Addendum #1

Architect's Project #: 20210217.06
Project Name: HACN Sequoyah

Heights Community

Center

OVERALL SITE PLAN

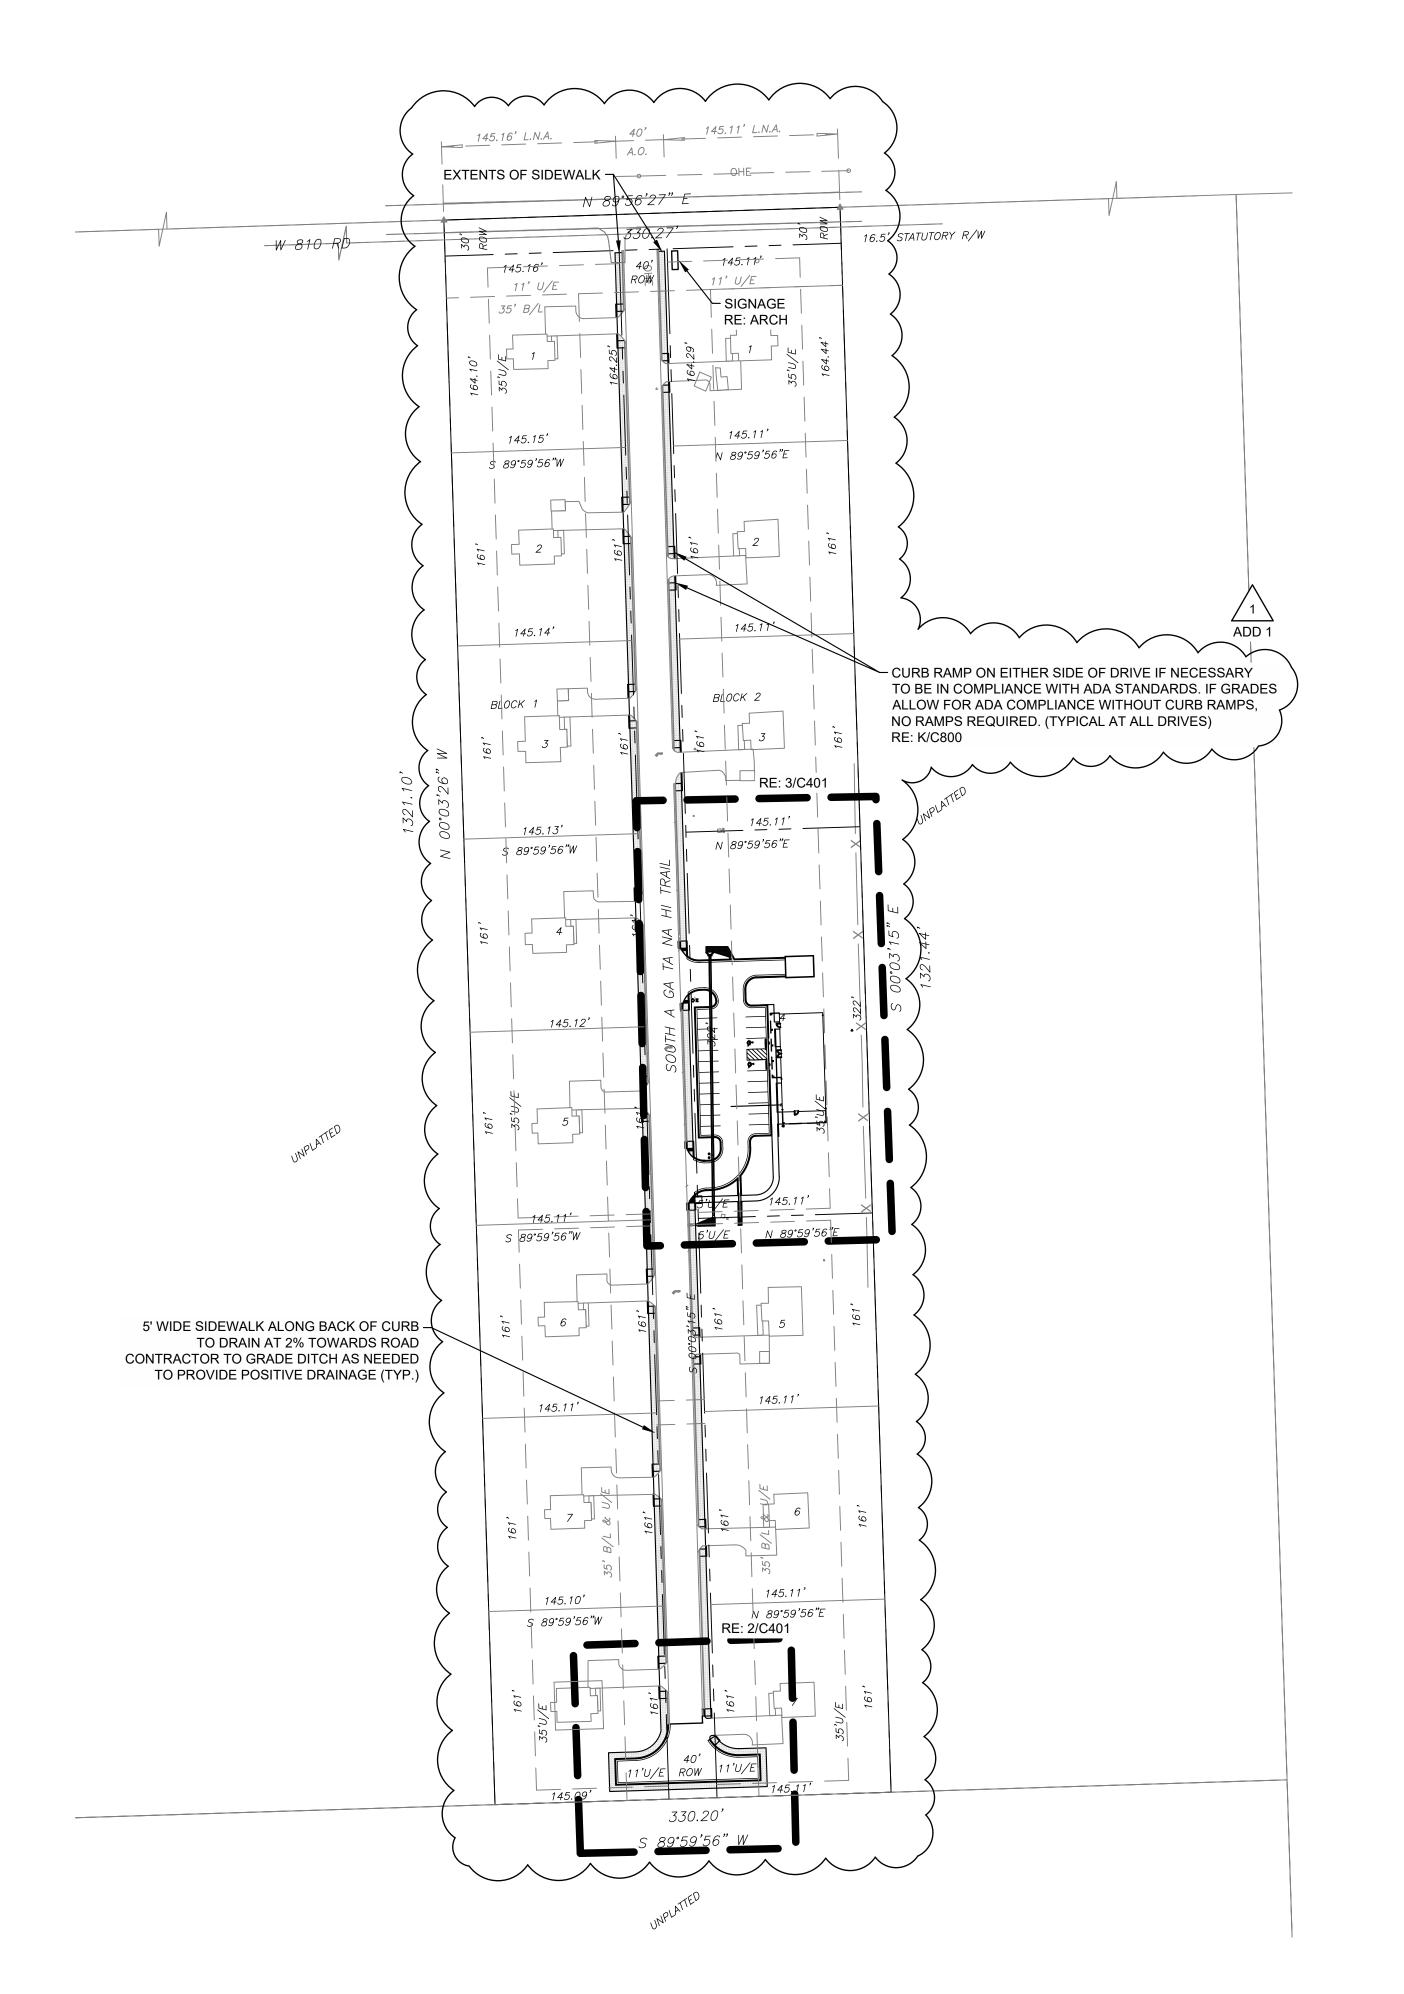
1. **Question:** The civil documents show ADA ramps at the driveways however they only show two of the existing houses. Should these ramps be at every existing driveway?

<u>Answer:</u> Refer to the revised C400, C401, C402, & C500 for additional information on the ADA ramps at the driveways. The replacement of existing driveways and the addition of ADA curb ramps is dependent on the existing grades at the driveways. Where the grades require a curb ramp, an ADA curb ramp is required. Where existing driveways have a greater than 2% cross slope that portion of the driveway needs to be replaced.
